Permit: RPPL 2021012893	Project No.: PRJ 2021-004513	Expires: 3/1/2024
Address: 5640 S. Fairfax Avenue, Los Angeles, CA 90056	APN: 5009-004-019	Approved on: 3/1/2022
Approved by: Alice Wong	Zone: A-2

This Plot Plan approves the 2022 Annual Drilling Plan to permit 10 potential locations for drilling and re-drilling wells. Abandonment of 12 wells. No new pads or pad restorations are proposed in 2022.

2022 Drilling, Re-drilling, Well Abandonment, and Well Pad Restoration Plan

Inglewood Oil Field

Attachment #2
2022 Visual Simulation Location Map

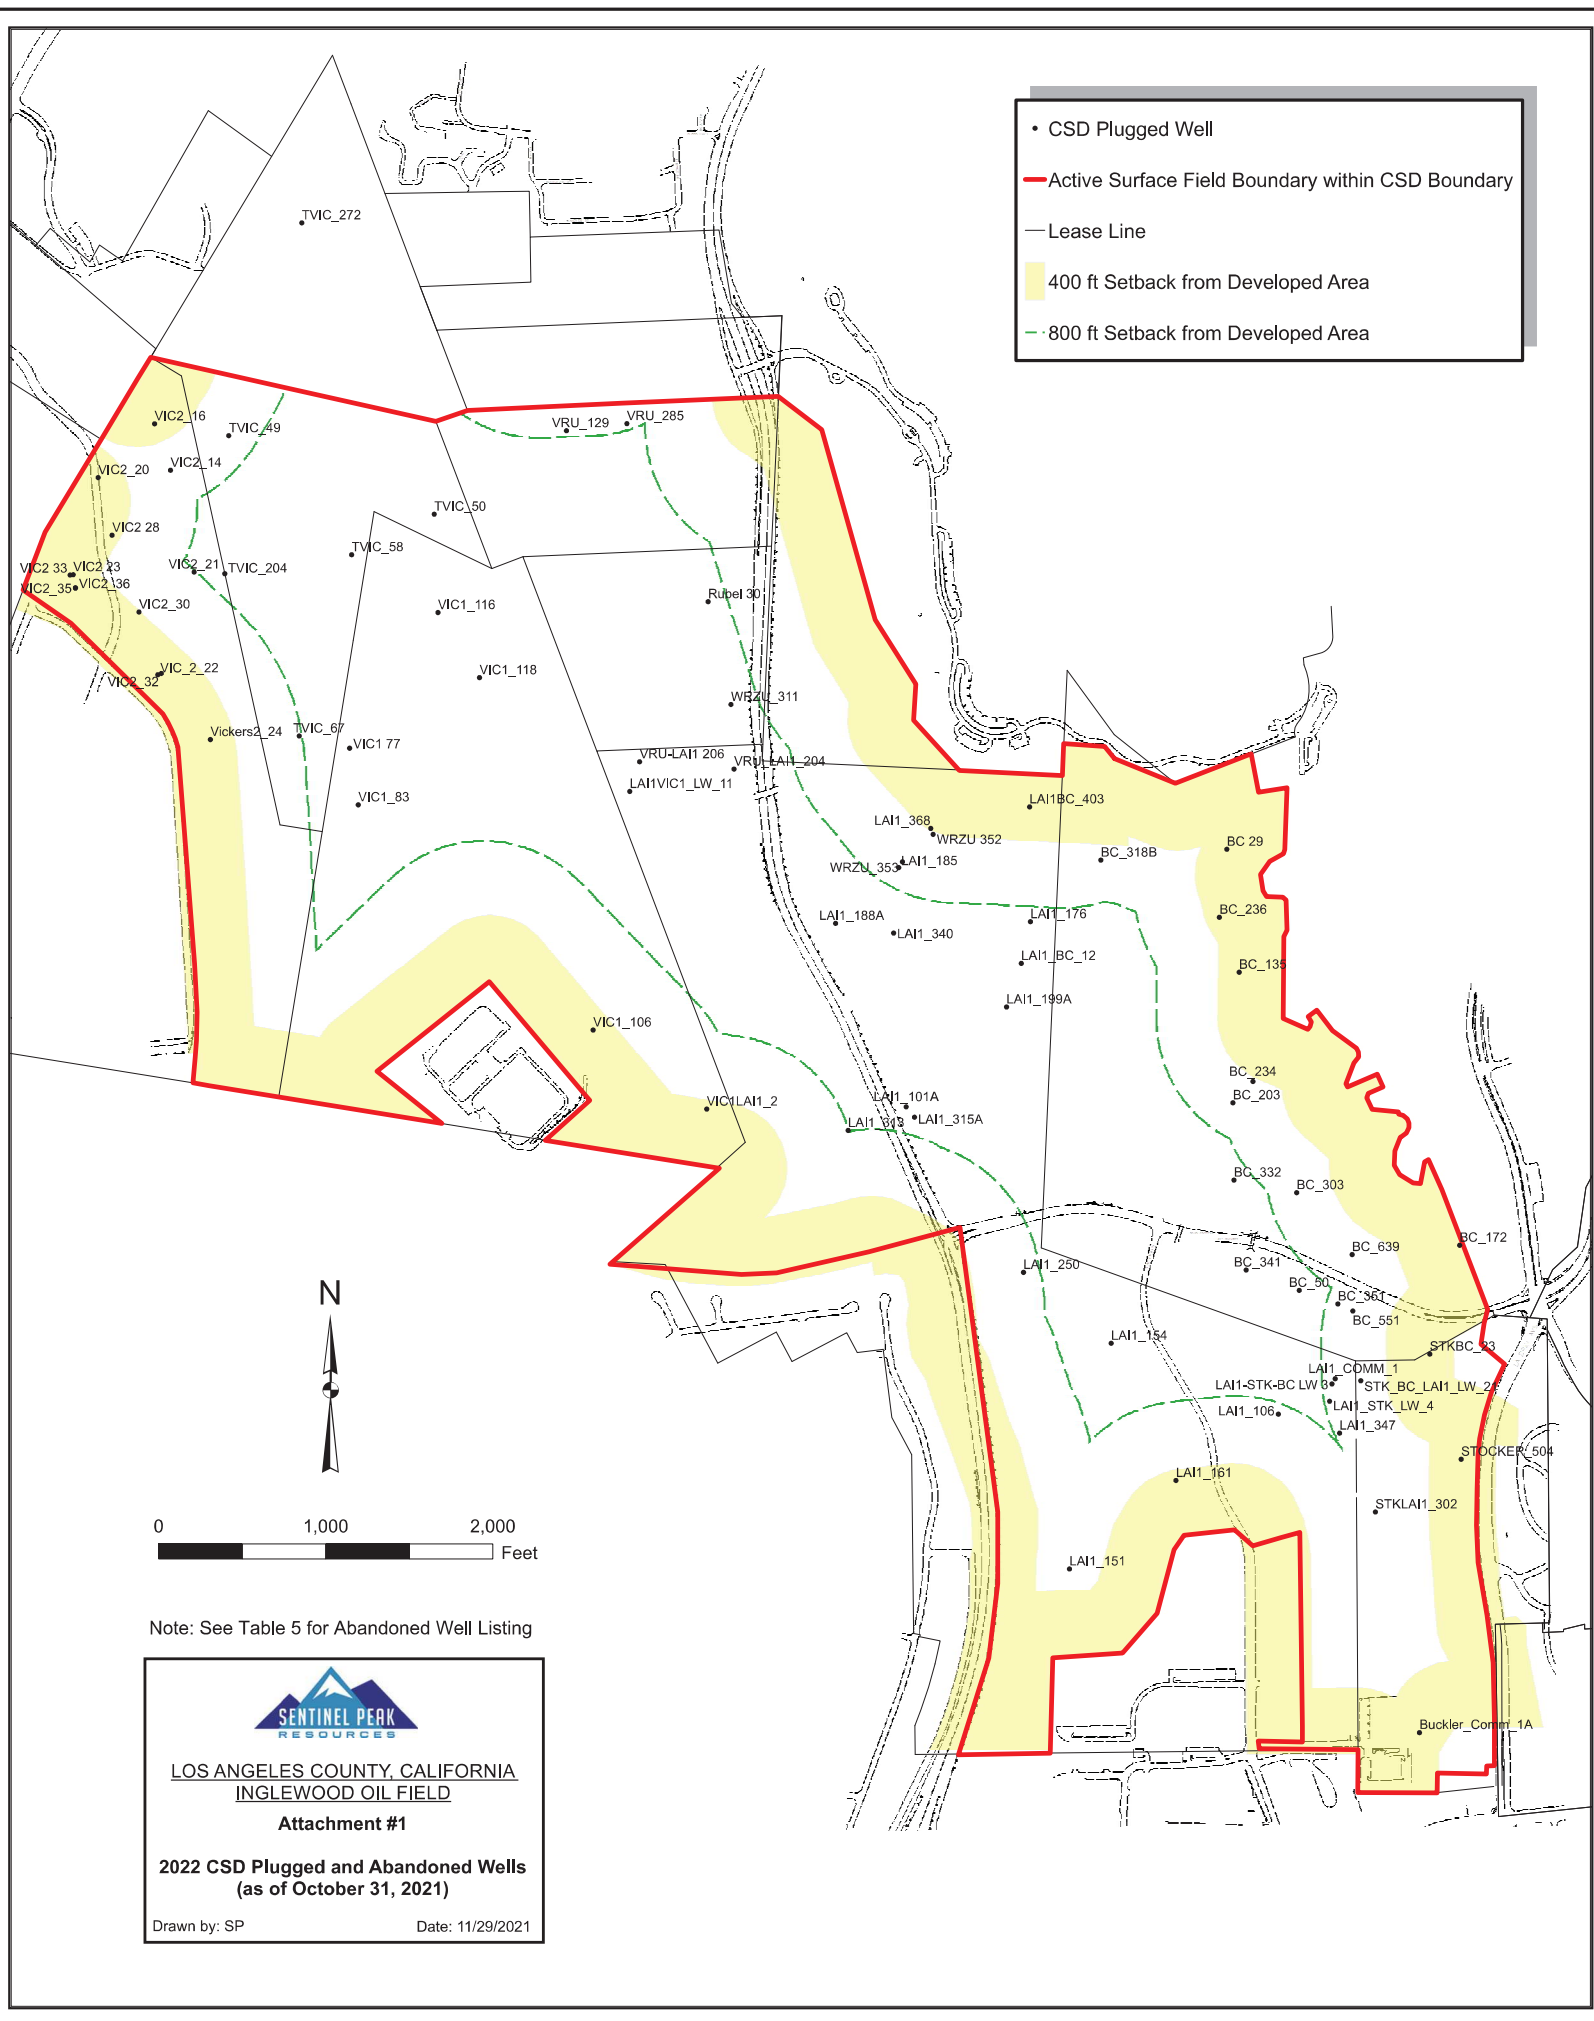
- The executive summary contains a typo and should read: "PR is not likely to drill new production wells next year..."

- 7B** View of the Inglewood Oil Field from Windsor Hills
- 6C** View of the Inglewood Oil Field from Ladera Heights
- 8A** View of the Inglewood Oil Field from West Los Angeles College
